Product Change Notification

110988 - 01

Change Notification #: 110988 - 01
Change Title: Intel® Server System R1304BTLSFAN, R1304BTLSHBN and R1304BTSSFAN, 3.5 inch Hot-Swap Backplane Spare FXX1304HSBP, Mechanical Spares Kit FR1304MSK, PCN 110988-01, Product Material, Change Chassis Mechanical, Reason for Revision: Update Quick Start User Guide (QSG) and Update TA, MM# and PBA
Date of Publication: November 28, 2011

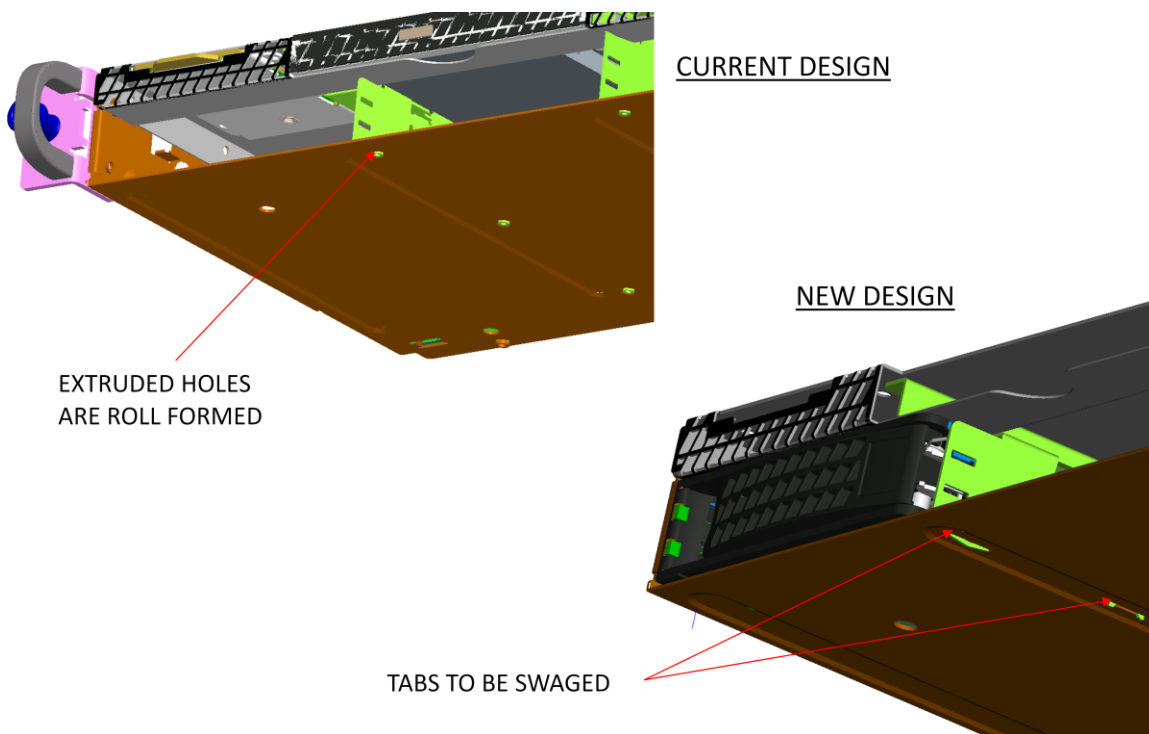
Intel will implement the following changes on the Hot Swap Backplane (HSBP) FXX1304HSBP, which is used in the Intel® Server System R1304BTLSHBN.

1. Move the locations of the SATA (hard drive) ports downward 0.43mm to support up to 26.11mm height hard drives.
2. Add two more mounting holes to improve the Hot Swap Backplane assembly. Below diagram shows the two new added holes.

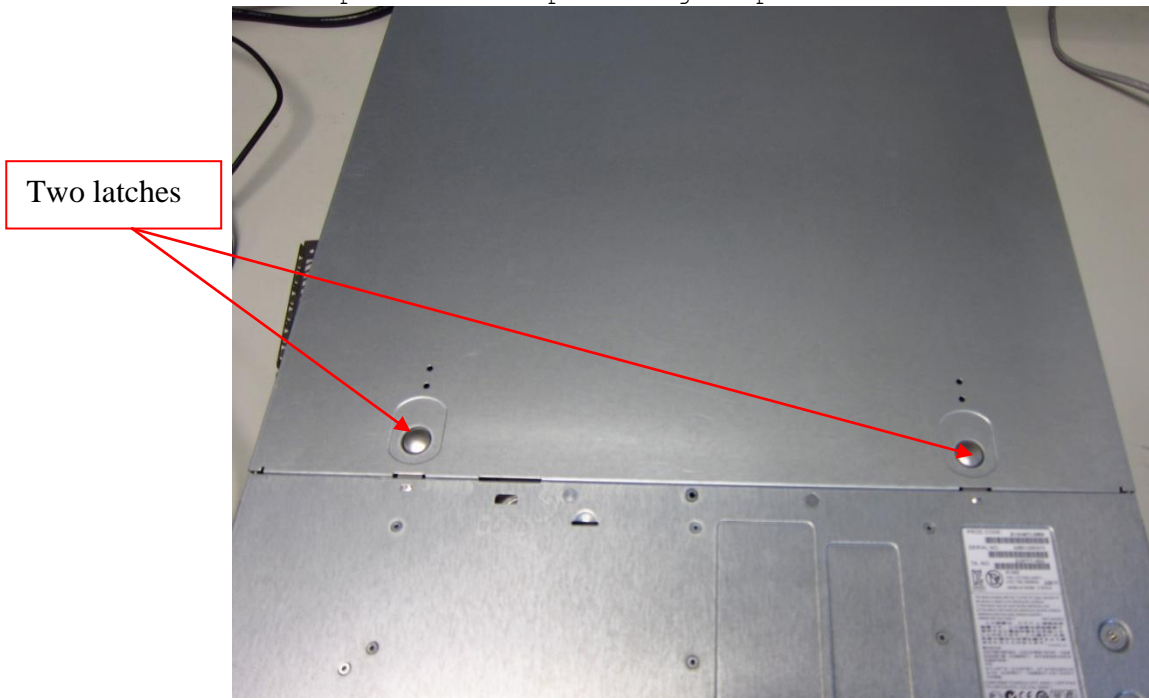
1. Change the hot swap front end design from the rivet design to use swagged tabs to support up to 26.11mm height hard drives. See the diagram below for the changes.

AF003680

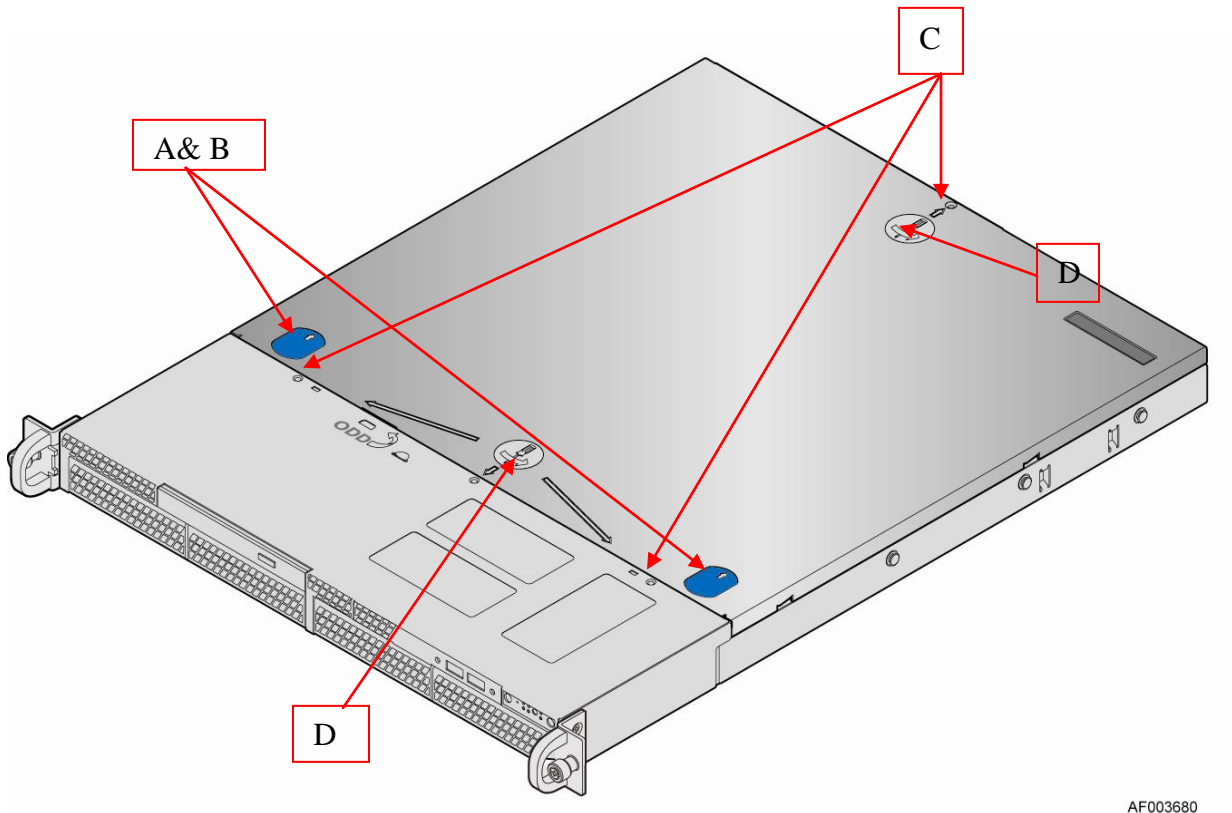
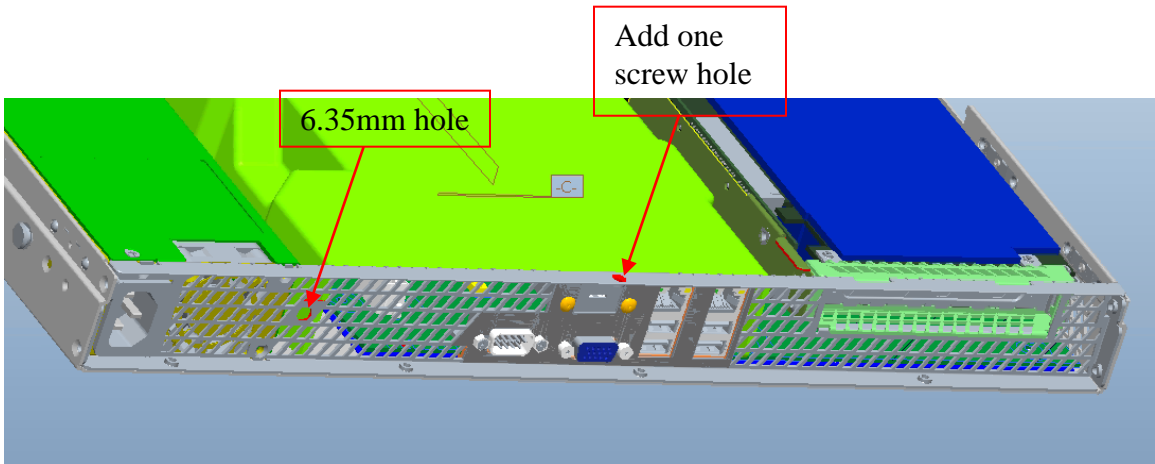
1. The top cover will have below changes:
 - A. Remove two latches.
 - B. Add two thumb pads.
 - C. Add three additional screws holes and screws to improve the top cover assembly.
 - D. Change the screw icon.

Below photo is the pre-change top cover.

Below drawing is the post-change top cover with the change A, B, C and D.

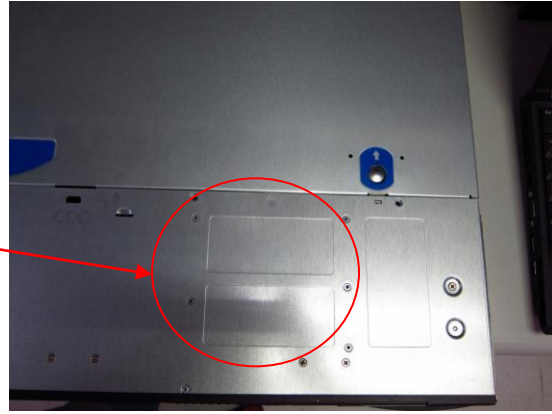
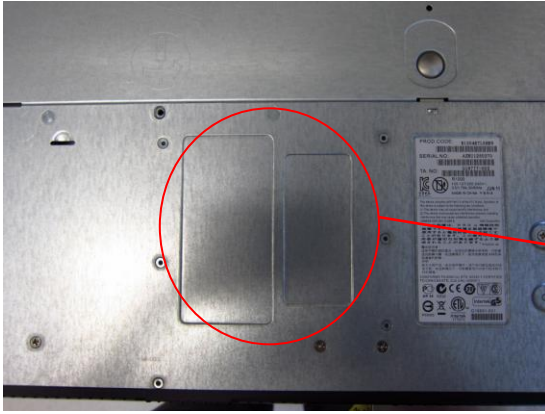
2. Change the rear panel on the chassis to hold the third party power cable.
 - A. Add one 6.35mm hole on the rear panel.
 - B. Add one screw hole on the rear panel to accommodate the additional screw hole being added to the top cover.
 Below is the drawing of the post-change part.

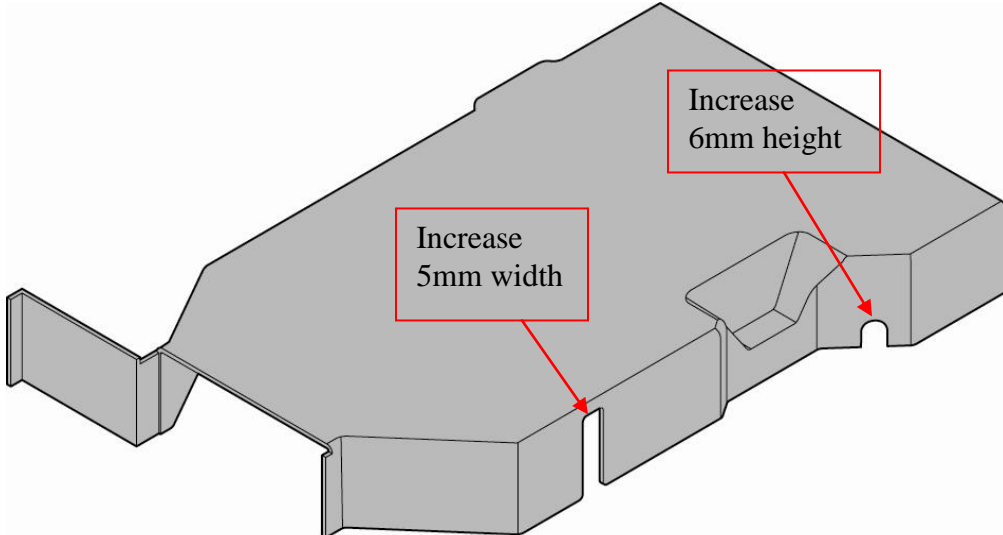
3. Change the label size and positioning at the front end of the chassis from 45mm x93mm and 33mm x 74mm (vertical labels) to two 40mm x 90mm (horizontal labels). See the picture below.

AF004870

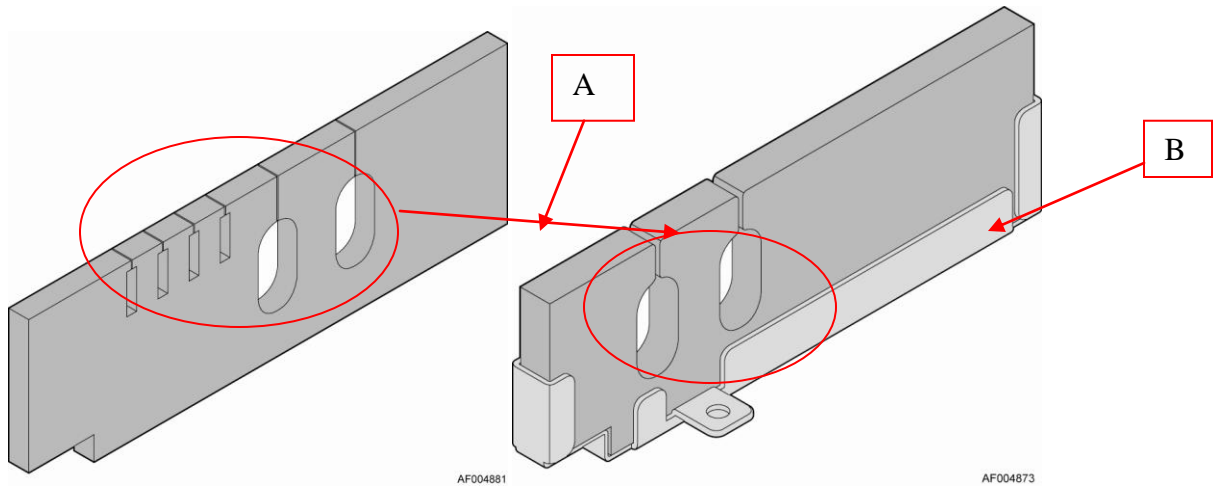
4. Update the air duct to increase cable slot space for improved serviceability. See the diagram below.
 - A. Increase the rear cable slot 6mm height to avoid bending of the power cable to accommodate the processor.
 - B. Increase the front cable slot 5mm width to avoid bending of the power cable to accommodate the server board.

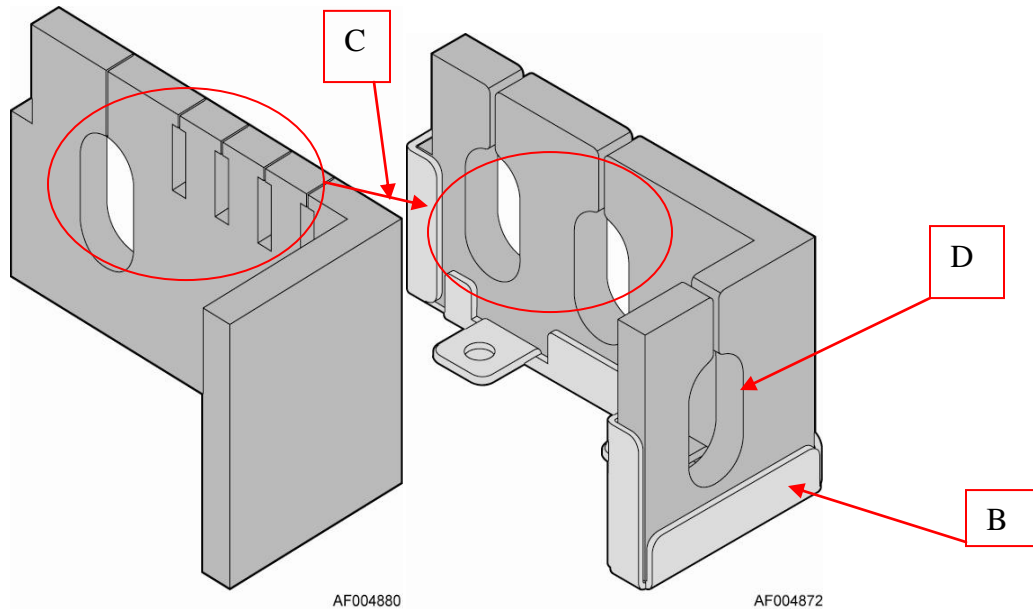
5. Change the air dam to improve the cable routing and to strengthen the air dam.
 - A. Change 6 small cable slots to two larger cable slots for the routing of the front panel cable and the internal USB cable.
 - B. Add a metal holder to strengthen the air dams.
 - C. Change 5 small cable slots to two larger cable slots for the routing of the SATA cables, the SGPIO cable and the I2C cable.
 - D. Add one cable slot for better cable routing from the SAS module.

Below left drawing is the pre-change air dam. The right drawing is the post-change air dam.
